Enclosure 2
Meeting Summary Handouts
of the February 16, 2011
ROP Public Meeting
Dated March 14, 2011

Open FAQs on NEI 99-02
Status Date: For 2/16/2011 ROP Public Meeting

NEI 99-02 FAQ TEMPLATE
Number 09-10, "Multiple Units at One or More Sites"
Revised February 15, 2011

Figure F-6

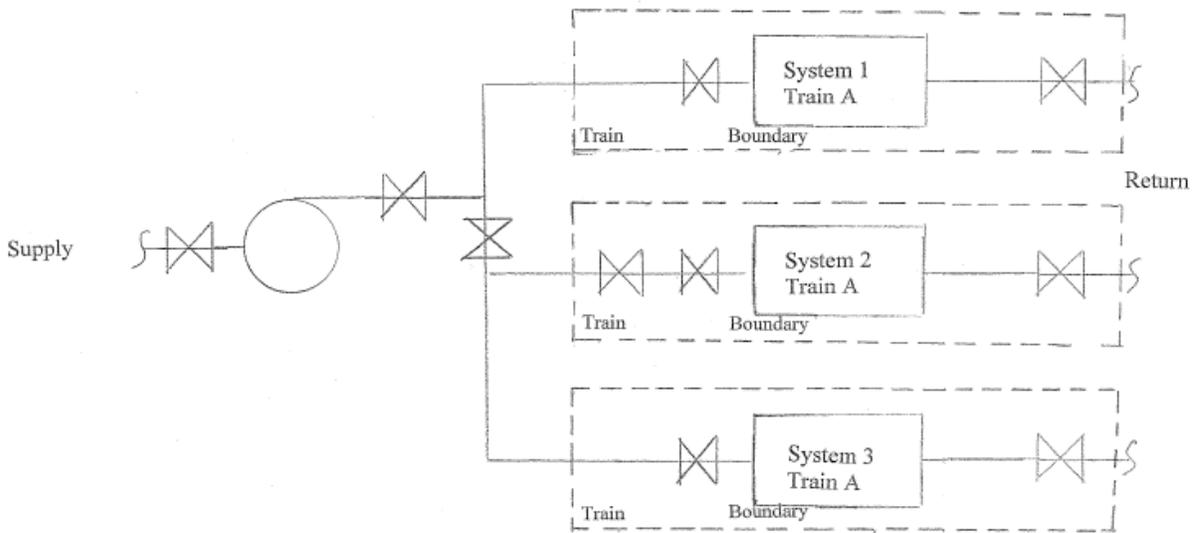
NEI 99-02, Rev. 6, provides guidance for the cooling water system scope on pages F-52 and F-53. The text from page F-53, lines 2 through 7, highlighted in italics below, indicates that only the last valve in a cooling water system line is included in the boundary of the monitored component. While this may be correct in most applications, there are plant configurations where a cooling water system line running to a monitored system (EDG for example) has more than one isolation valve (e.g., manual isolation valve(s)). If the isolation valve(s) were closed it would only result in supported train unavailability and would not affect the availability of the cooling water system. However, the guidance on page F-53, lines 2 through 7, could lead one to the opposite conclusion and suggest that the cooling water system would be unavailable.

Question - Should a cooling water system isolation valve(s) in a line supplying a single monitored component be included in the monitored train's system boundary?

Response - Yes. A cooling water system isolation valve(s) in a line supplying a single monitored train should be included in the monitored train's system boundary.

Revise NEI 99-02, Rev. 6, Page F-53, lines 1 through 9, to read as follows:

necessary to provide cooling to the other monitored ~~systems-trains or segments~~ are included in the cooling water system scope up to, but not including, the ~~last~~ isolation valve(s) that connect(s) the cooling water support system to components in a single monitored ~~system~~ train or segment. This ~~these~~ last isolation valve ~~s~~ is/are included in the other monitored ~~system-or~~ traintrain or segment boundary. If the last valve provides cooling to SSCs in more than one monitored ~~system-or~~ traintrain or segment, then ~~it-the~~ valve is included in the cooling water support system. If the cooling water line to a single monitored component or traintrain or segment contains components (e.g., manual isolation valves or motor operated valves (MOVs)) that would only affect the monitored component or traintrain or segment, those components are included in the-other systemmonitored train or segment boundary. Figure F-4-6 depicts the treatment of multiple isolation valves. Service water systems are typically open “raw water” systems that use natural sources of water such as rivers, lakes or oceans. Component Cooling Water systems are typically closed “clean water” systems.
